**MEETING AGENDA
SESSION OF THE HISTORIC PRESERVATION BOARD
CITY OF KISSIMMEE
CITY HALL, COMMISSION CHAMBERS
101 CHURCH STREET, KISSIMMEE, FLORIDA 34741-5054
MONDAY, JANUARY 8, 2024 AT 5:15 PM**

509 Verona Street

New 72-square foot machine room at 509 Verona Street.

- 17'-8 3/4" 2nd. FLOOR BEARING HT.
- 16'-4 3/4" 2nd. FLOOR HEADER HT.
- 9'-8 3/4" 2nd. FINISH FLOOR HT.
- 8'-0" 1st. FLOOR BEARING HT.
- 6'-8" 1st. FLOOR HEADER HT.
- 0" FINISH FLOOR

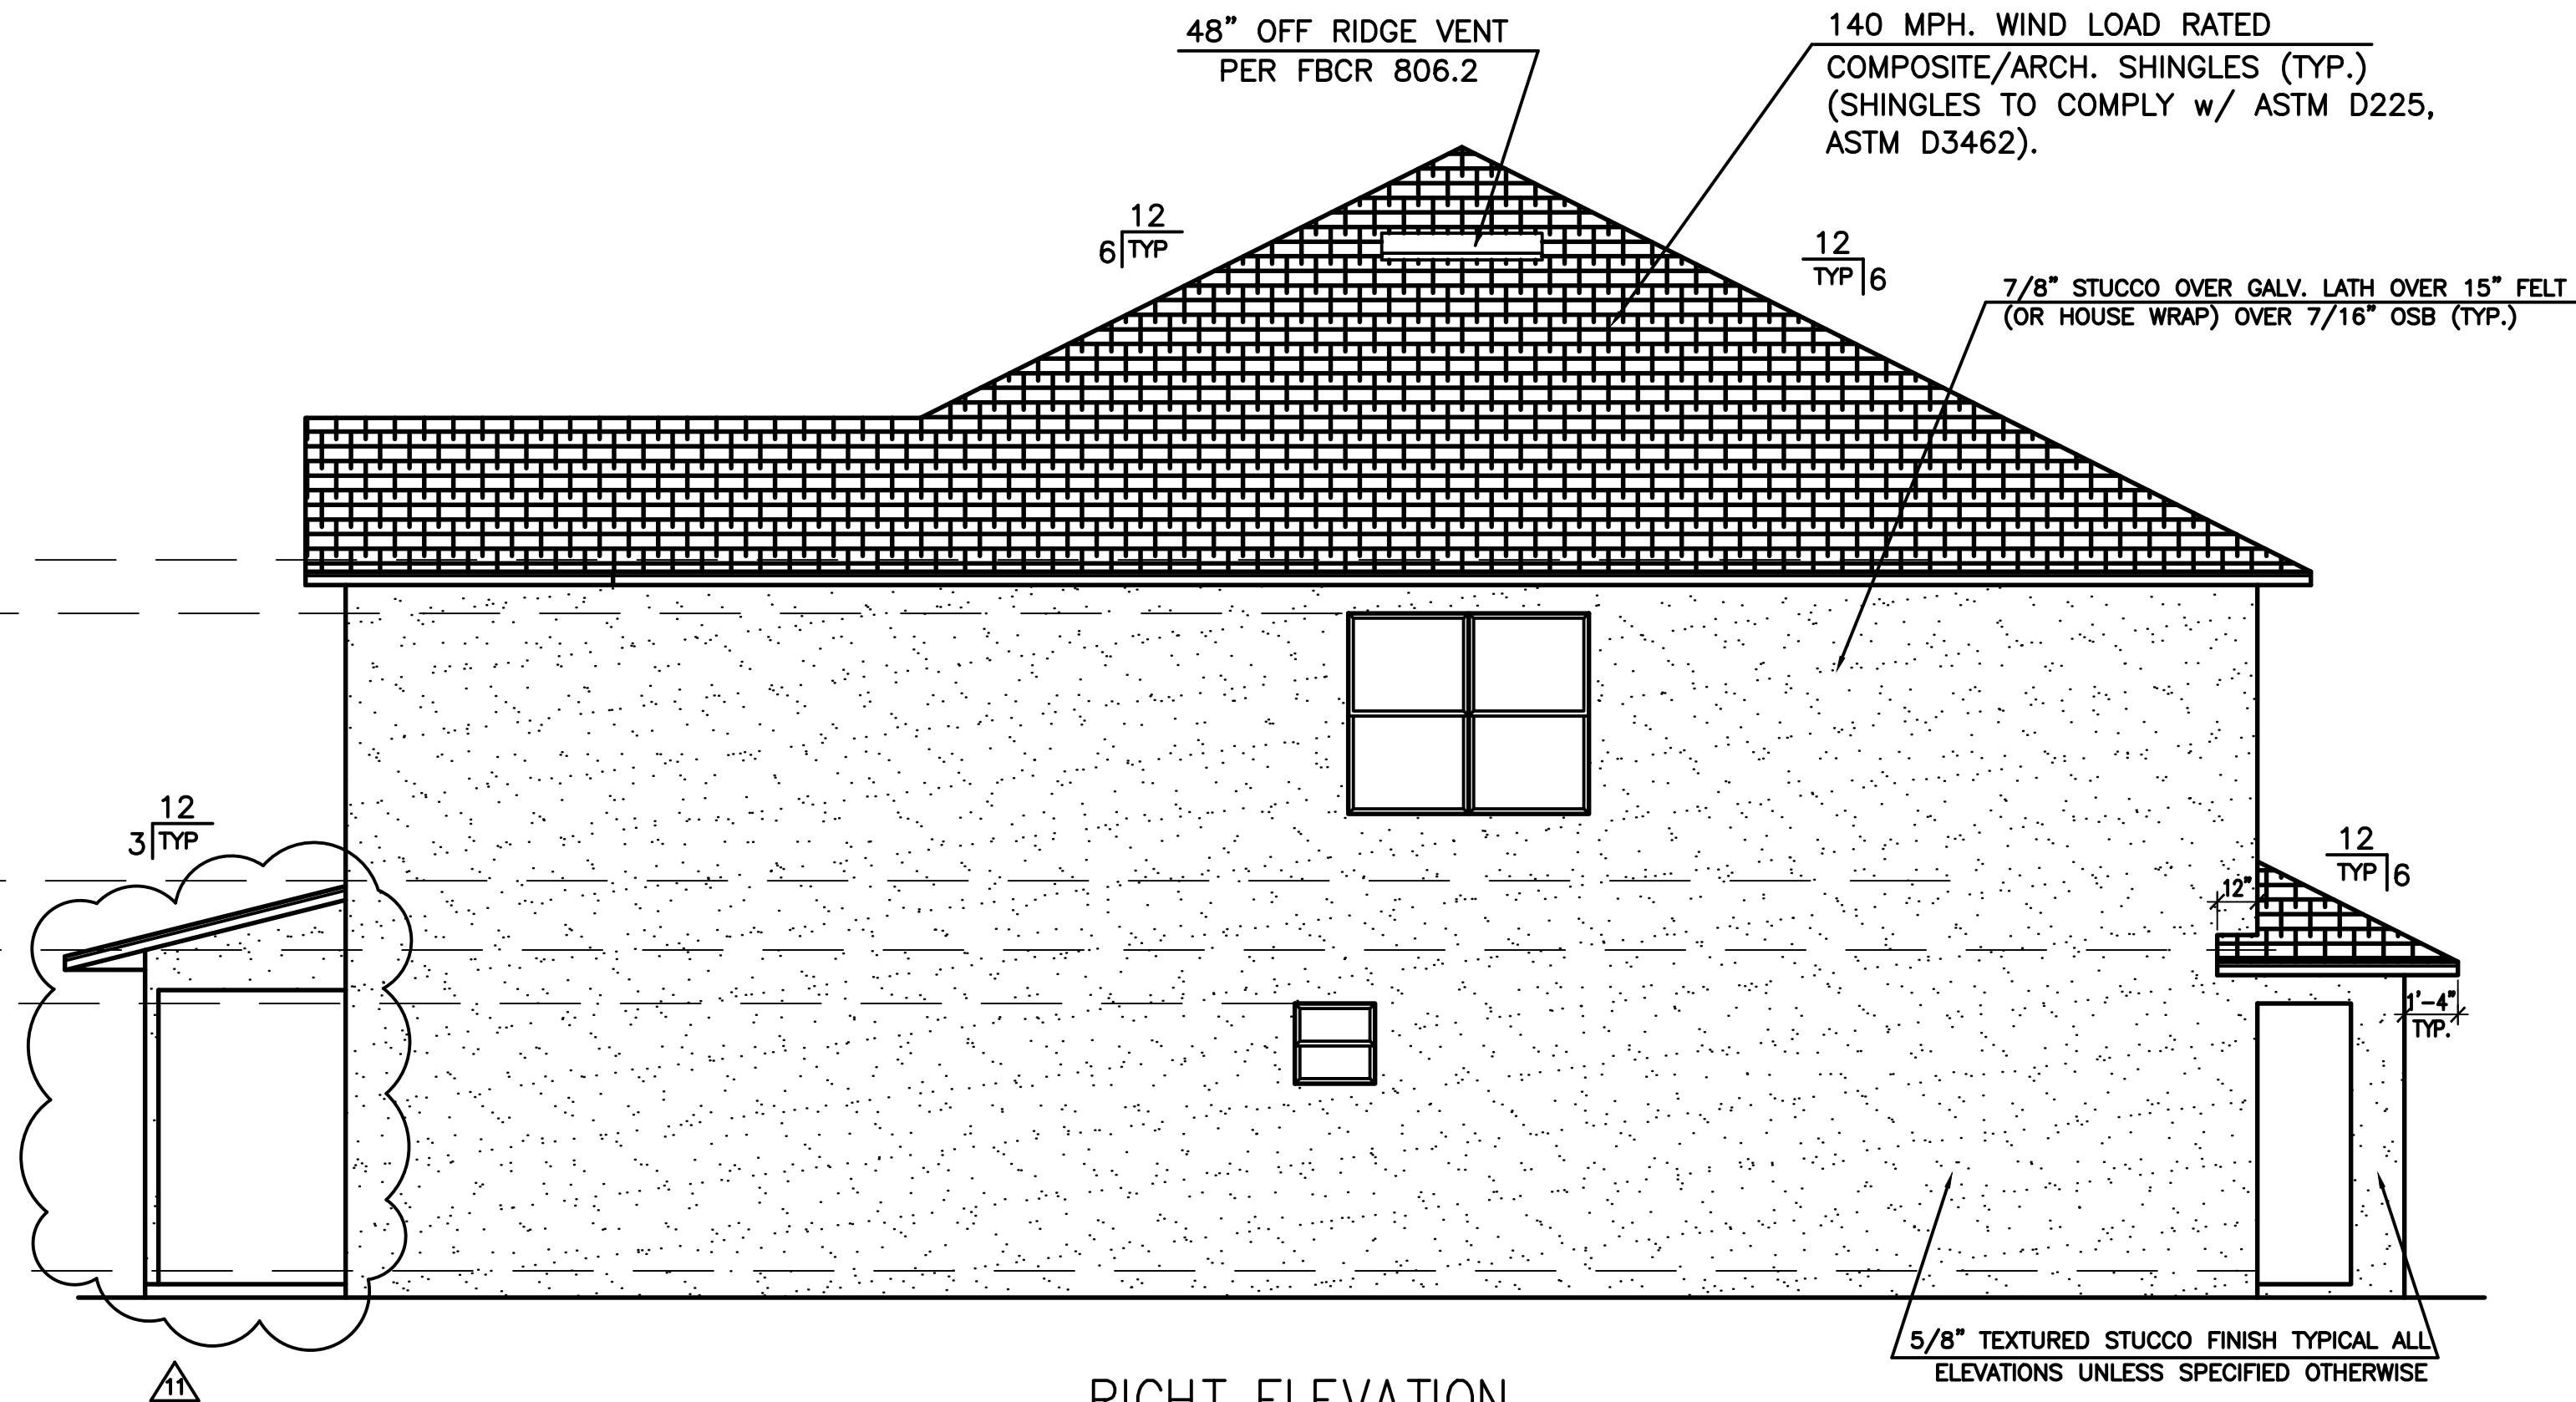
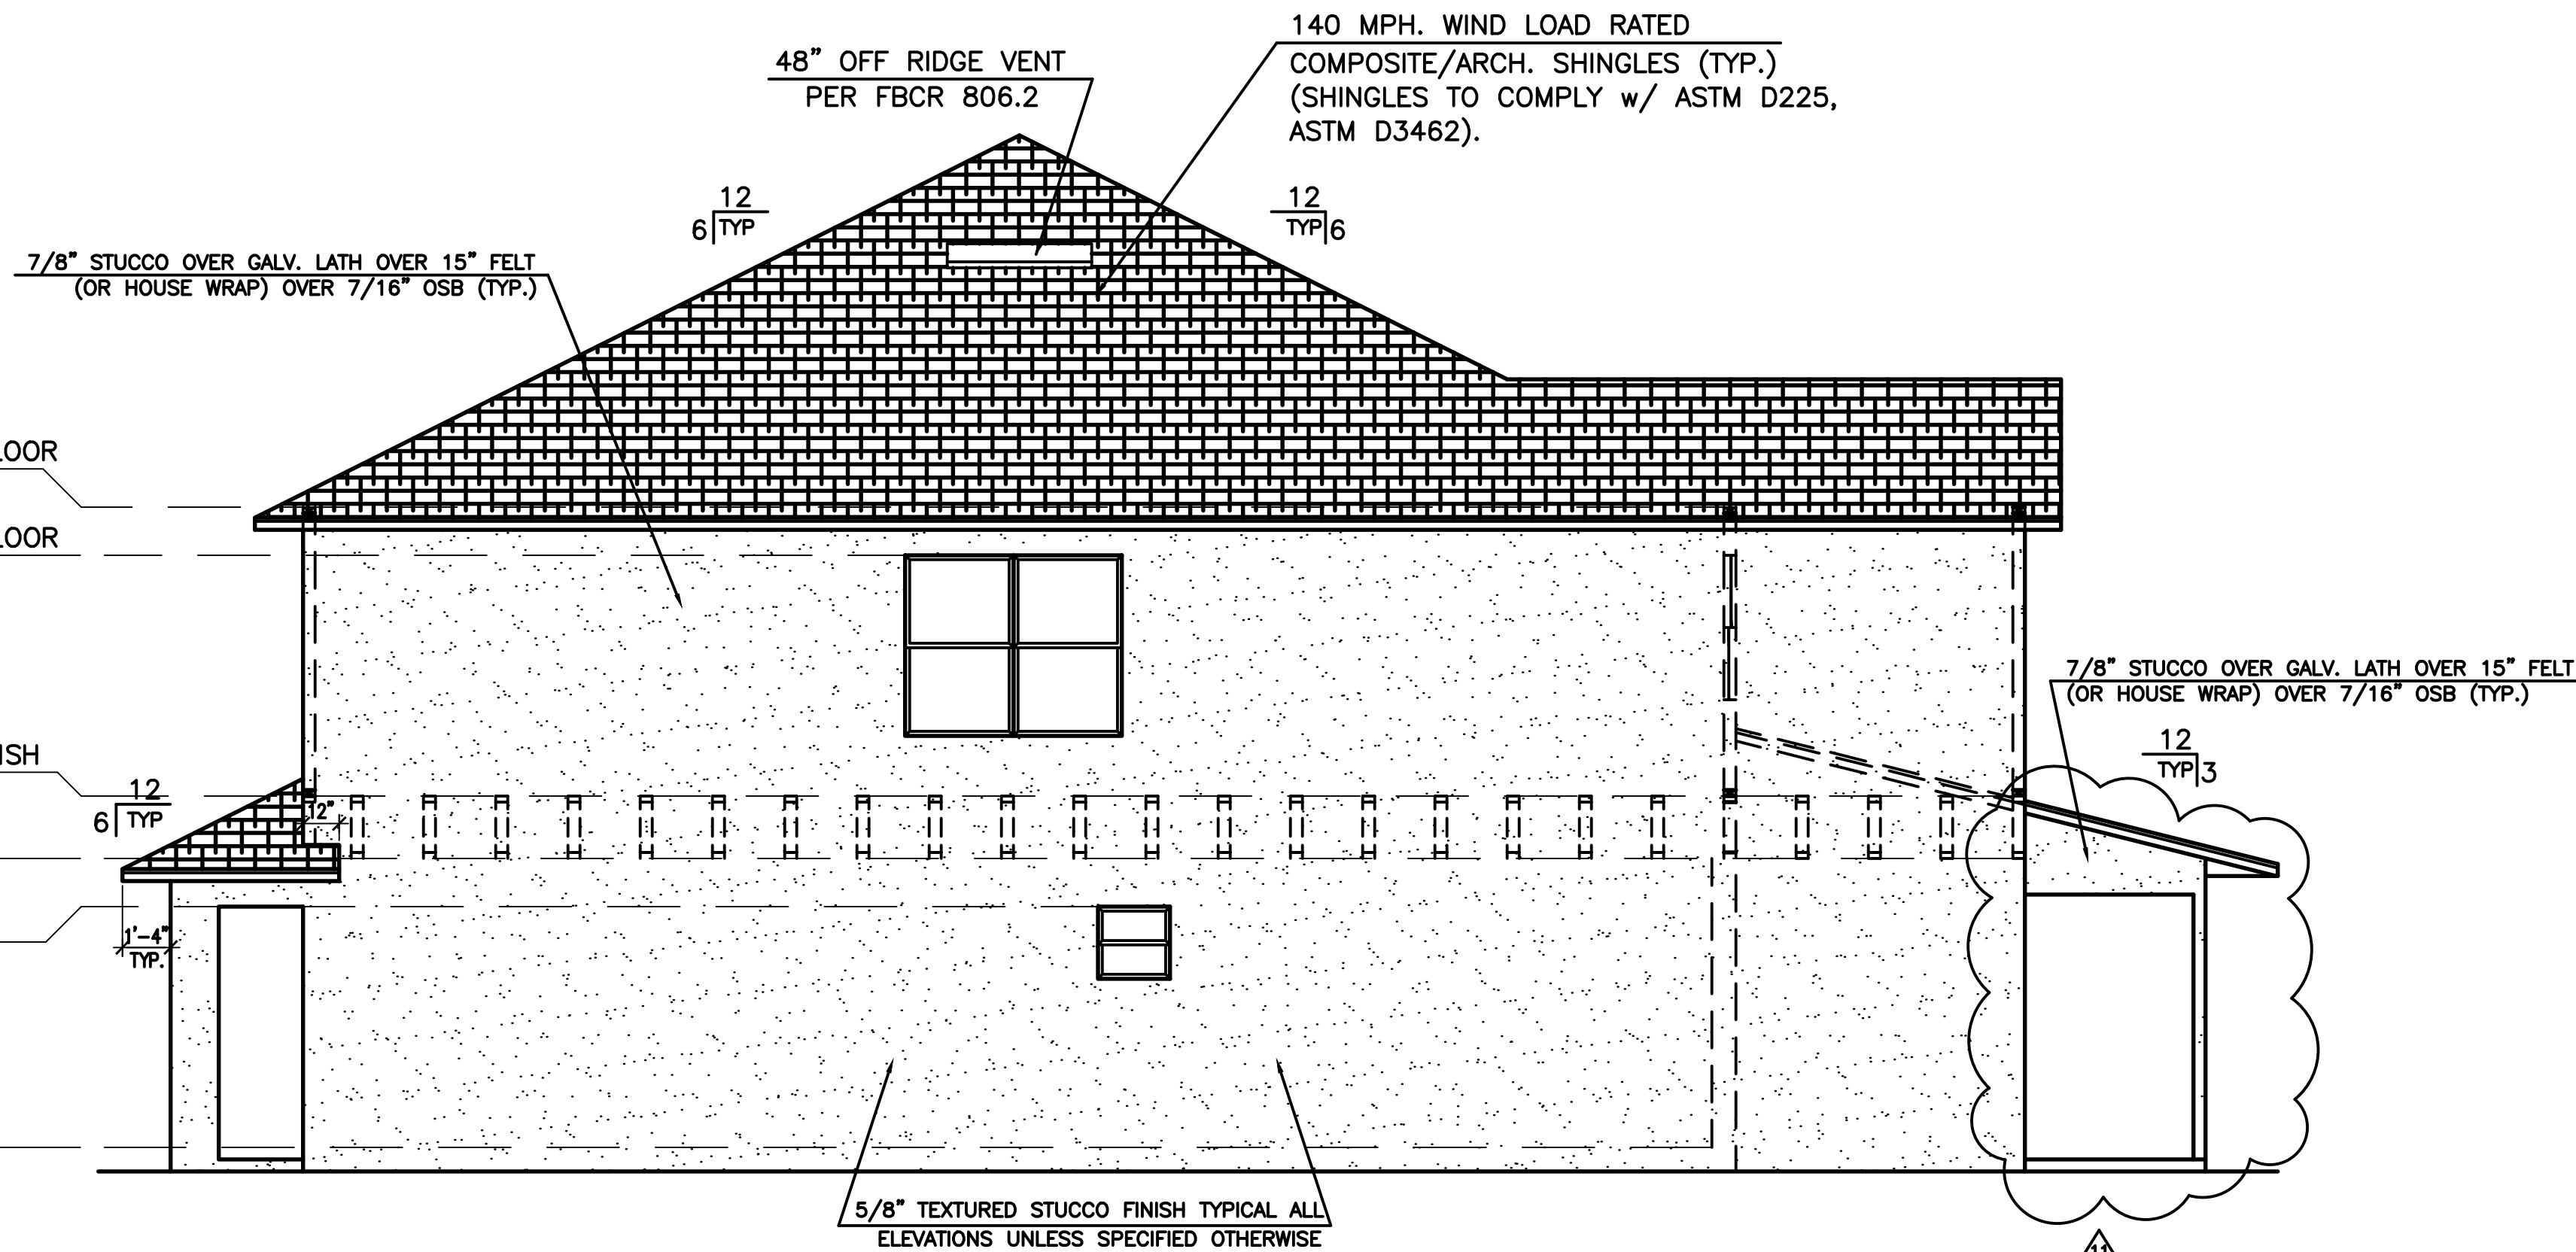
Since this property is on the edge of the South Beaumont district, and the only parcel fronting on Harford within the district, staff did not hold issue with a more modern design for the front of the structure. However, the proposed building is two stories and will be approximately 40-feet from the back of single-story structure at 725 Mabbette and the back and rear elevations will be seen from Mabbette. Due to this, staff is recommending that the applicant add architectural features to those elevations (sides and rear) to provide relief to the almost blank walls currently proposed. It is recommended to add additional windows and use some of the features from surrounding structures (e.g. a wide banding around the windows, a different window style, shutters, even window placement, and/or varying roof levels on the back). This will help make the transition between new and historic less awkward while respecting this property's location and proximity to newer construction.

Approval with the conditions that additional features be added to provide a smoother transition to the historic structures to the south.
